| <b>Subject:</b><br><br><b>CHECK ENGINE LIGHT ON WITH DTC P0300-P0304</b> | <b>Bulletin No:</b> 01-014/16  |
|  | <b>Last Issued:</b> 06/10/2016 |

2013-2016 CX-5 vehicles with VINs lower than JM3KE\*\*\*\*\*802960 (produced before April 7, 2016)

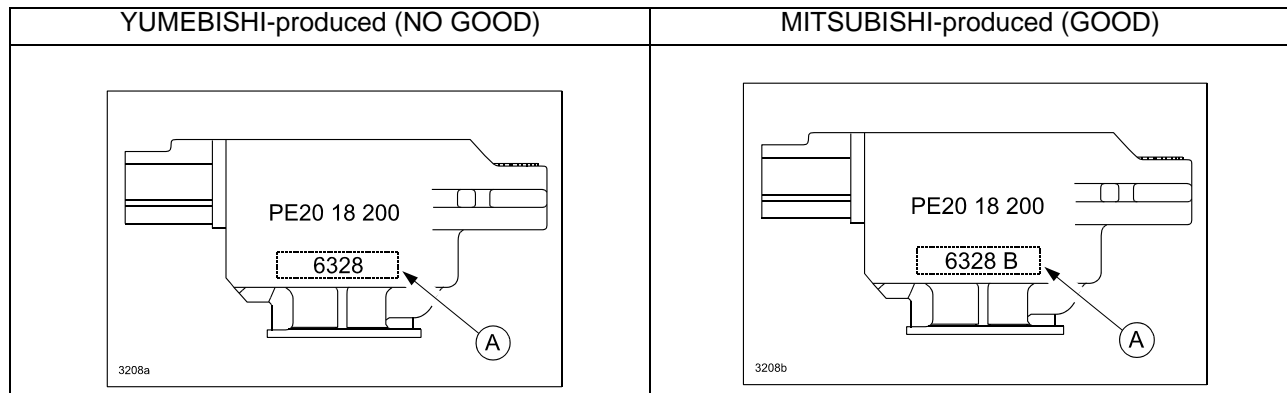
**NOTE:** The ignition coils are supplied from two different vendors, YUMEBISHI and MITSUBISHI. This concern only occurs on YUMEBISHI- produced ignition coil.

To distinguish between YUMEBISHI and MITSUBISHI ignition coils, look at their lot numbers (A). YUMEBISHI have 4 digit lot numbers and MITSUBISHI have 5 digit lot numbers as shown.

**NOTE:** There is no part number change. Differentiate the new modified ignition coil (YUMEBISHI-produced) from the old one by the lot number on the ignition coil. Ignition coils with the lot number of 6328 (March 28, 2016 production) or higher are modified.

## REPAIR PROCEDURE

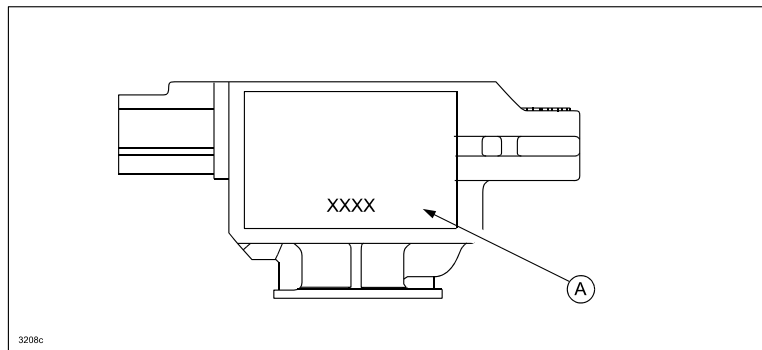
1. Verify the customer concern and the misfire related DTC(s) exists using the M-MDS.
2. Switch the two ignition coils of the cylinder with a misfire (identified by the misfire DTC) and a cylinder without misfire.

- If the misfire transfers to the other cylinder, the ignition coil is defective. Go to next step.
  - If the misfire does not transfer, a different cause such as malfunction of the wiring harness, spark plug etc. is possible. In this case, this TSB is not applicable. Perform further diagnosis according to the workshop manual.

3. Replace the defective ignition coil(s) with modified one(s) according to the workshop manual (section 01-18).  
CX-5: IGNITION COIL/ION SENSOR REMOVAL/INSTALLATION [SKYACTIV-G 2.0, SKYACTIV-G 2.5].  
Mazda3: IGNITION COIL/ION SENSOR REMOVAL/INSTALLATION [SKYACTIV-G 2.0, SKYACTIV-G 2.5].  
Mazda6: IGNITION COIL/ION SENSOR REMOVAL/INSTALLATION [SKYACTIV-G 2.5].

4. Check if any of the other non-defective coils are YUMEBISHI-produced and made before lot number 6328 (March 28, 2016 production). If any were made before this date, replace them with modified one(s) as well.
